February 9, 2012
U7-C-NINA-NRC-120013
10 CFR 2.390

South Texas Project
Units 3 and 4
Docket Nos. 52-012 and 52-013
Response to Requests for Additional Information

RAI 09.01.02-9**QUESTION:**

RAI 09.01.02-17**QUESTION:**

Figure 13: Baseline Corrected X Displacement

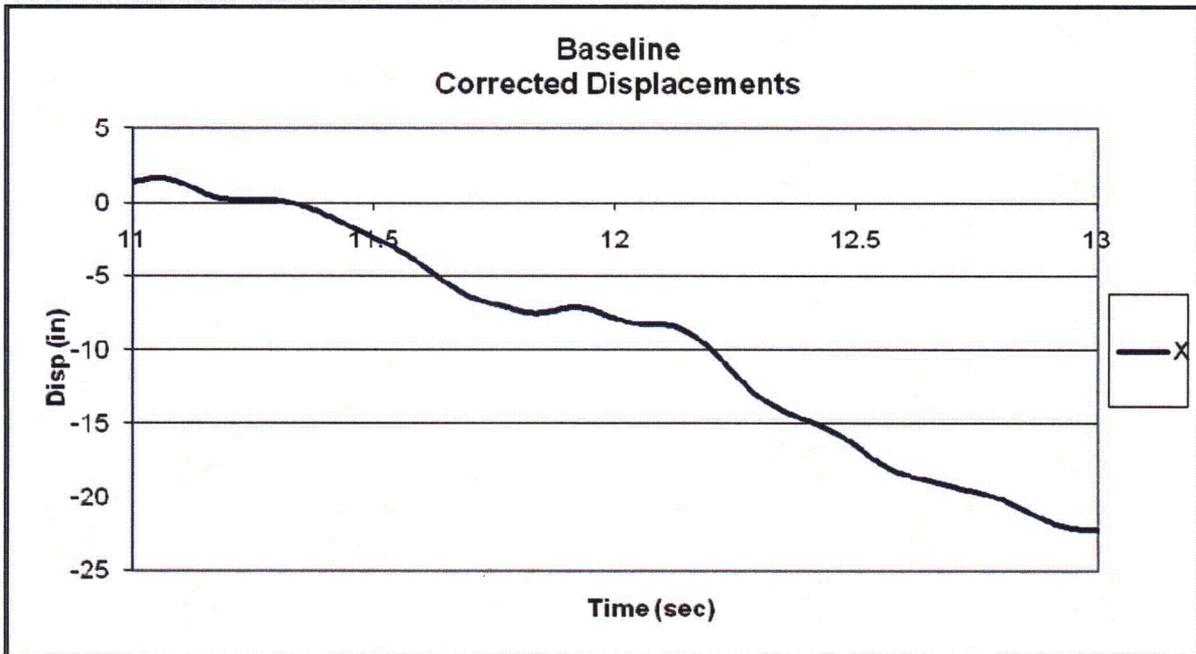
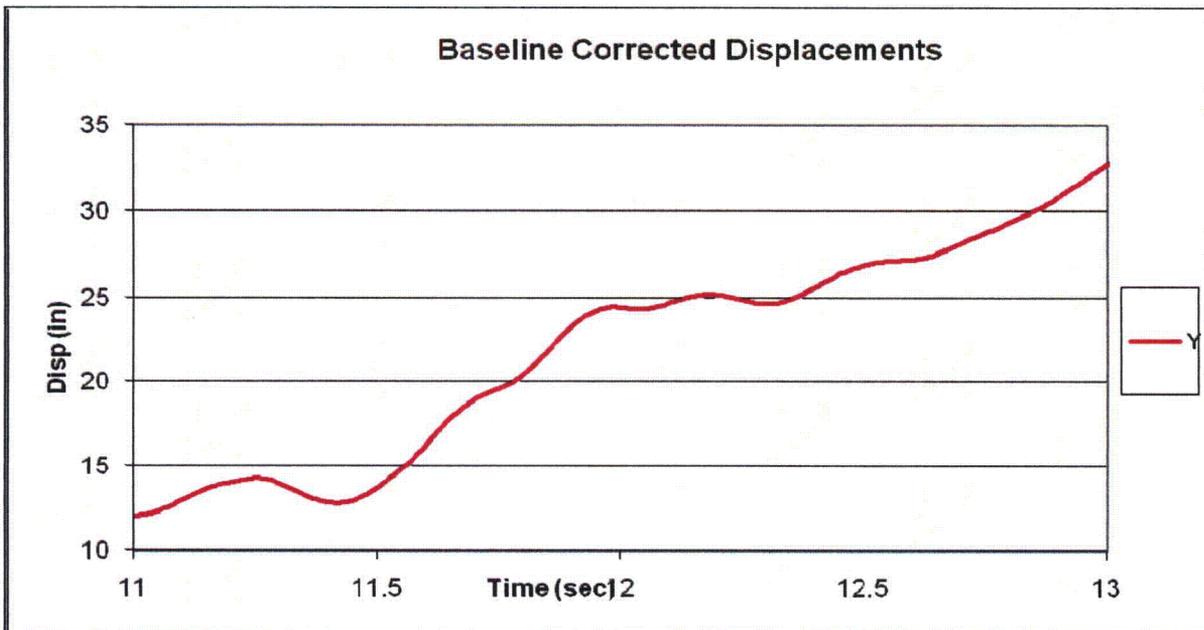
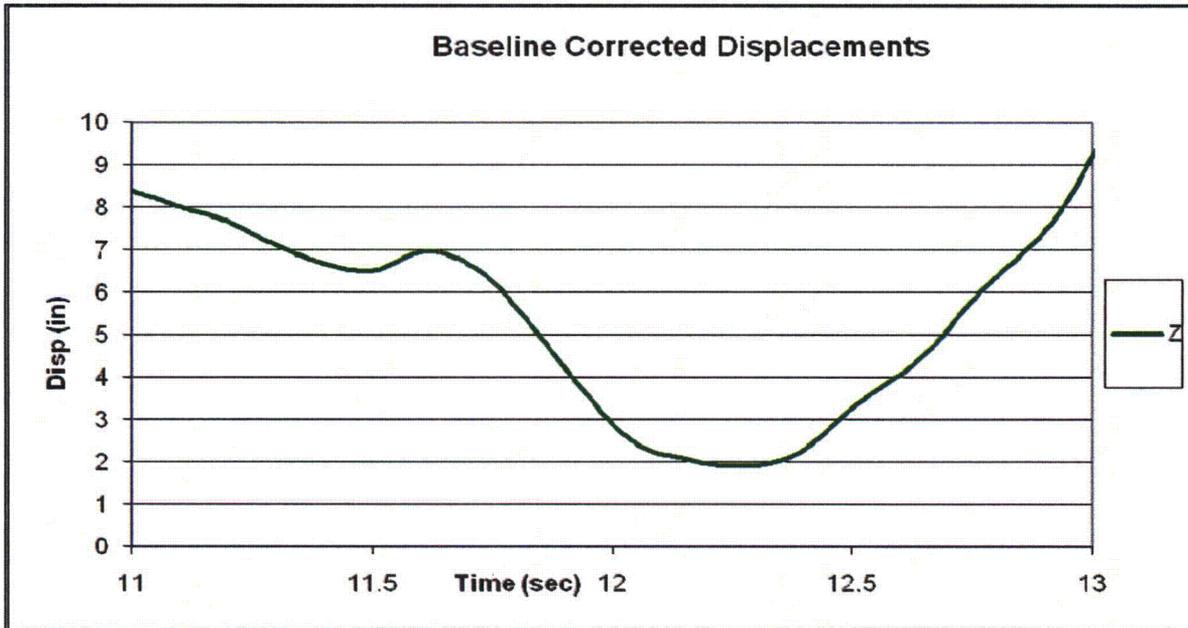
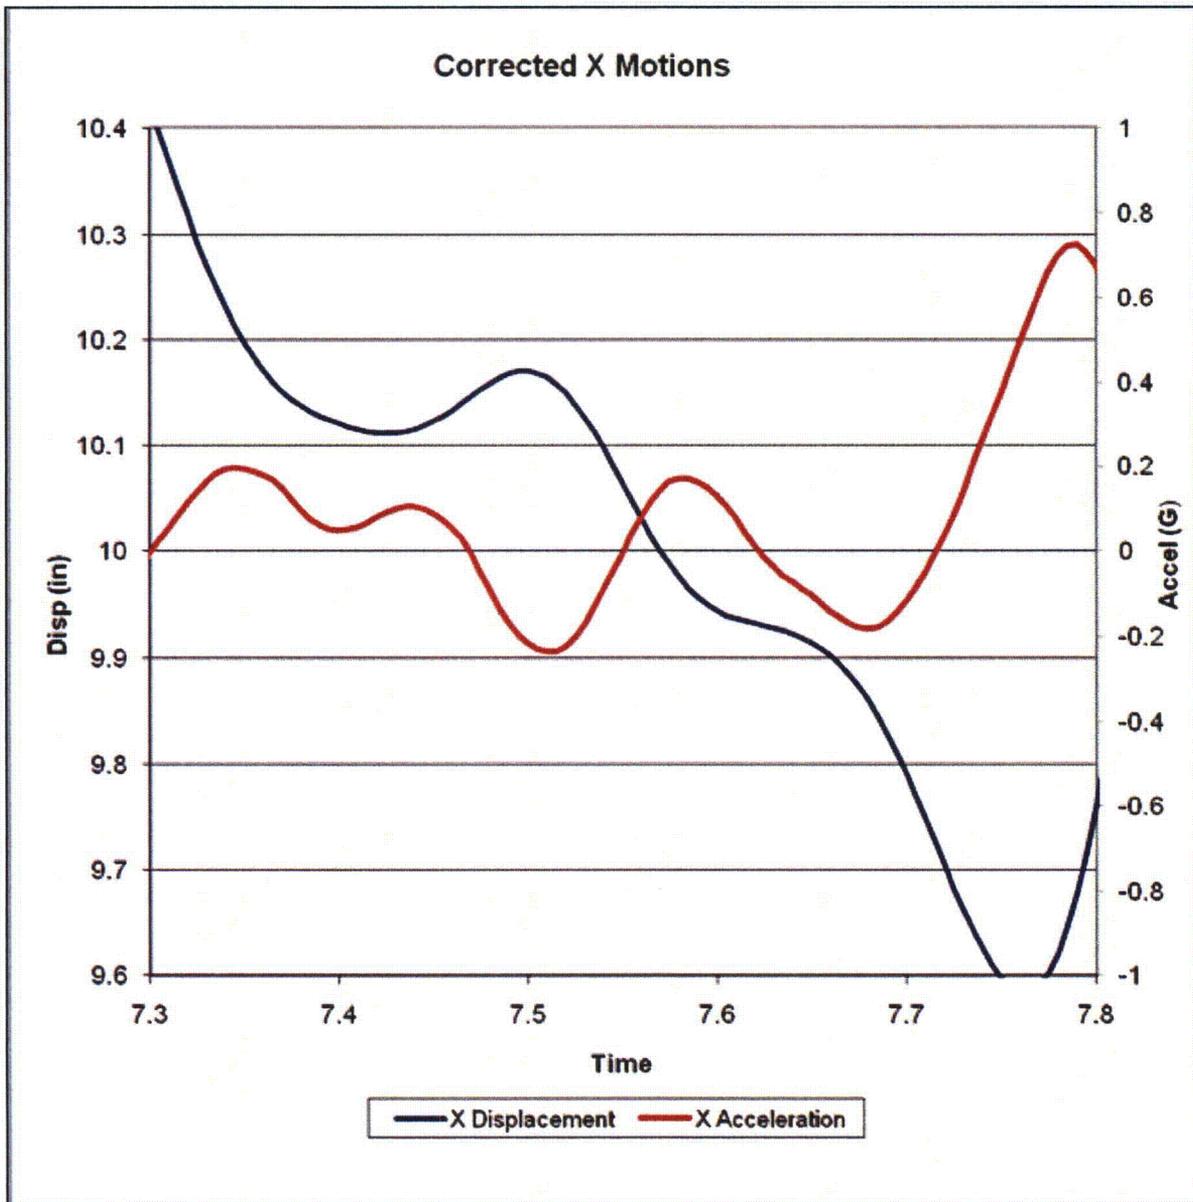
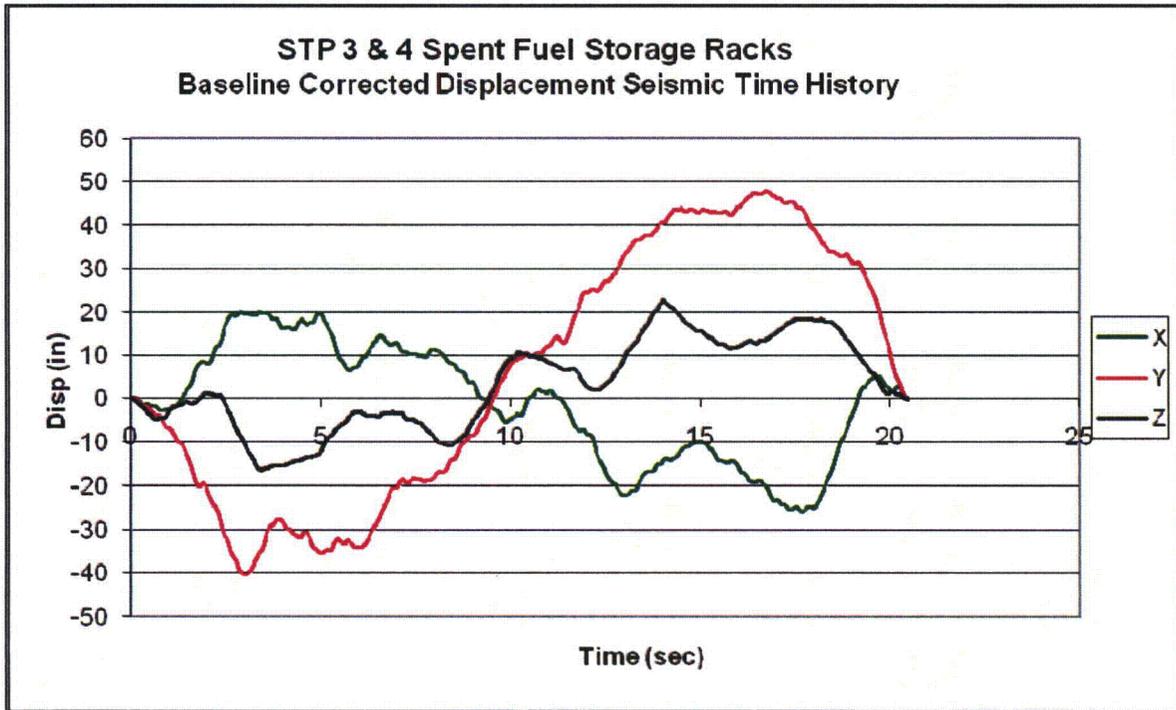
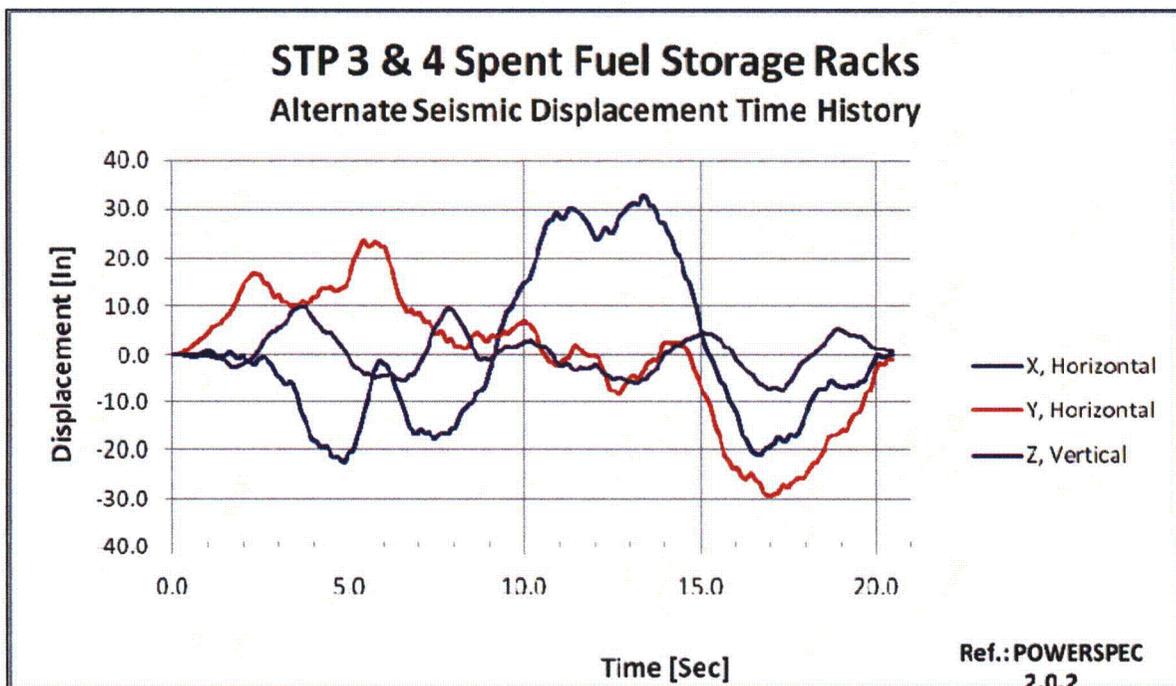
- f. The plots of the baseline corrected displacement time histories (x, y, z) presented in Figure 4-5 of the Technical Report exhibit several characteristics that require clarification and explanation: (1) All 3 displacement time histories exhibit a dominant sinusoidal response with a period which is same as the duration of the acceleration time history (2) All 3 displacements are zero at three specific time steps. (3) Although there is only 1 horizontal target spectrum, the peak x displacement is approximately $\frac{1}{2}$ of the peak y displacement. (4) The 2 horizontal displacement histories are completely out-of-phase with each other; the vertical displacement history is perfectly in-phase with y and completely out-of-phase with x. Describe how the displacement time histories are developed from the synthetic acceleration time histories, and provide the technical basis for the adequacy of the generated displacement time histories.

- (2, 3 & 4) The magnitudes and phasing of these large displacement low frequency motions in the three application directions is a mathematical idiosyncrasy without any effect on the response of the fuel racks.

The displacements are the double integration of baseline corrected acceleration time histories that satisfy statistical independence criteria. All fuel rack results reported are relative to the floor motion. Figures 13, 14, and 15 show the baseline corrected displacement time histories on a magnified time scale. These figures show that the high frequency displacements in each direction are not in phase and are not a constant ratio of each other. Figure 16 shows a portion of the X motion for the corrected acceleration time history and the corrected displacement time history, which is calculated by double integrating the corrected acceleration time history. The fuel racks dynamically respond to the higher frequency, smaller amplitude cyclic waves shown in these plots. Figure 17 shows Technical Report Figure 4-5 with the data point markers removed.

The comparison between the baseline corrected and alternate displacement time histories (double integration of the synthesized acceleration time histories using the second method described in the response to RAI 09.01.02-9(d)) is shown in Figures 17 and 18, respectively. Figures 17 and 18 both show low frequency, large amplitude displacements containing superimposed high frequency, low amplitude displacements. The fuel racks dynamically respond to the higher frequency smaller amplitude cyclic waves shown in both figures. Figures 19, 20, and 21 show the alternate displacement time history on a magnified time scale for each of the applied directions. Figures 19, 20, and 21 reflect high frequency, low amplitude characteristics that are similar to Figures 13, 14, and 15.

As additional confirmation that the baseline corrected time history is valid, both displacement time histories were applied to a single fuel rack model (a single, stand-alone rack). The maximum fuel impact load, mount impact load, and vertical displacements were calculated and showed excellent comparison, as summarized below:

Figure 4-1 Seismic Input and ANSYS® FEM Coordinate Directions

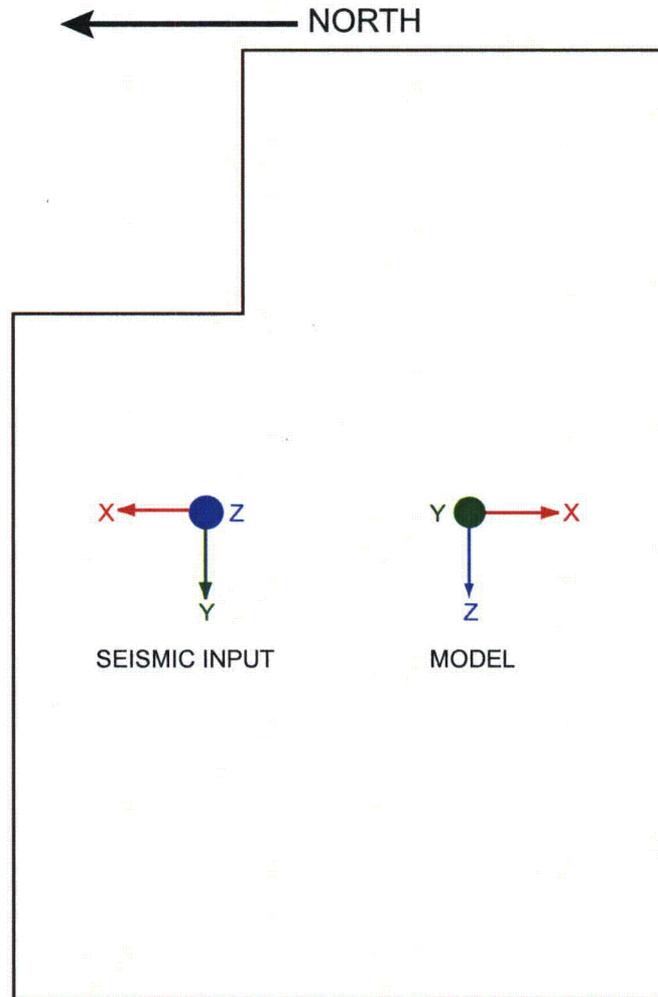
3. Figure 4-1 appears to be a plan view. If this is a plan view, then Y is vertical and Z is horizontal west. This is inconsistent with the text in Section 4.1, which defines Y as horizontal west and Z as vertical. Correct the text and figures to be consistent. Also confirm that the seismic input was properly applied in the 3 coordinate directions.

3. There were two coordinate systems used in the analysis of the Spent Fuel Storage Racks. The seismic inputs coordinate system is as described in the first paragraph of Section 4.1 "Time History Inputs," and is consistent with the time history plots presented in Figures 4-2, 4-3, 4-4, and 4-5. This differs from the coordinate system used by ANSYS[®] software for the FEM modeling as graphically portrayed on several of the ANSYS[®] figures. Figure 4-1 will be revised as shown below to clearly indicate the differences between the two systems.
